**SUNDRY NOTICES AND REPORTS ON WELLS**  
Do not use this form for proposals to drill or to re-enter an abandoned well. Use Form 3160-3 (APD) for such proposals.

Saguaro AGS Federal Com #12

RE: Plugging and Abandonment Requirements, Conditions of Approval

**After**

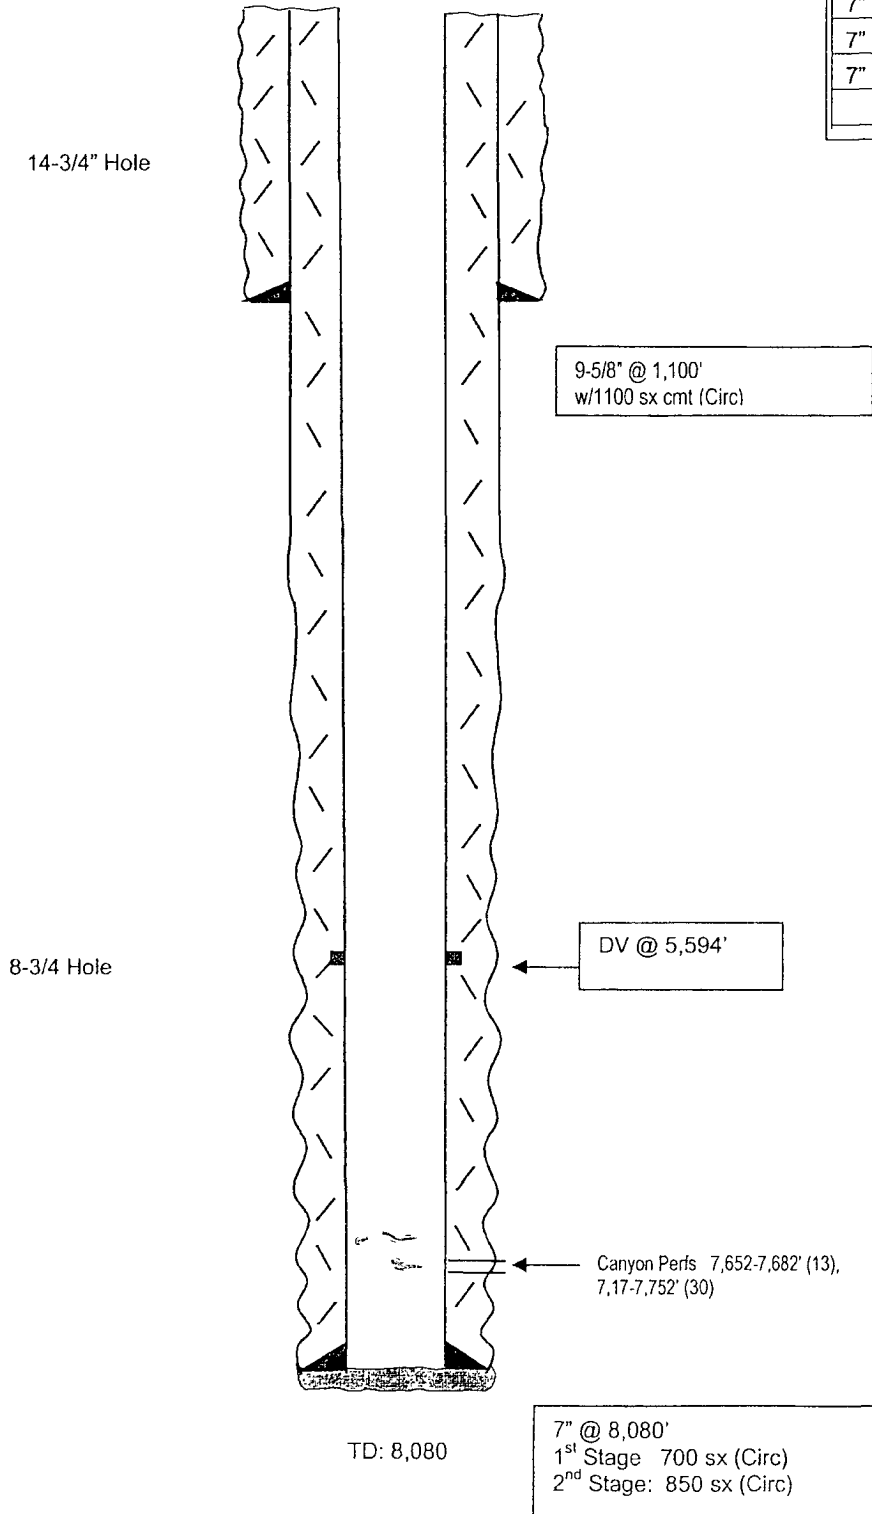
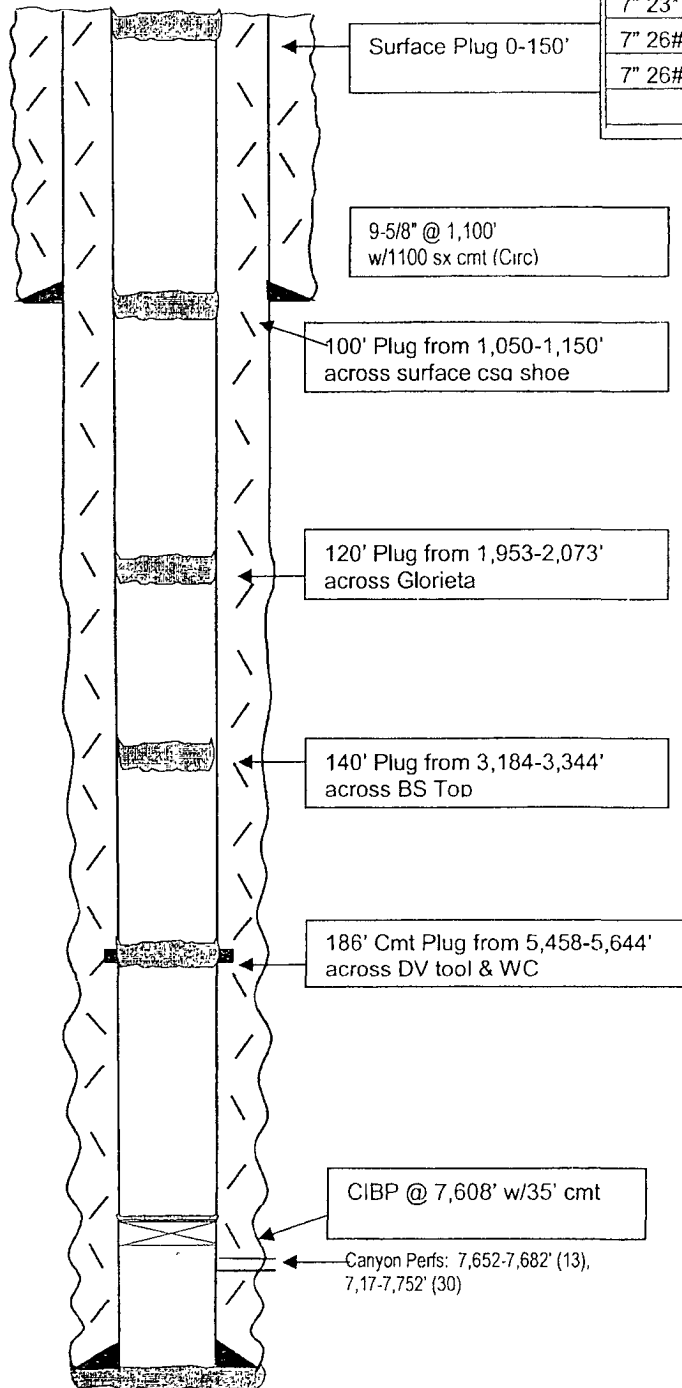
1. OK
2. Cement should be Class H – Otherwise OK (Perfs)
3. Tag at 5458' or shallower – Otherwise OK (Wolfcamp – DV Tool)
4. OK (Bone Spring)
5. OK (Glorietta)
6. Plug to be a minimum 110' in length. Tag at 1040' or shallower – Otherwise OK (Casing shoe)
7. CHANGE: Spot the plug from 400' and fill casing to surface. (Cave/Karst – Surface)
8. Verify Cement to surface in all annuluses – Otherwise OK.
9. Submit a subsequent report to the BLM.
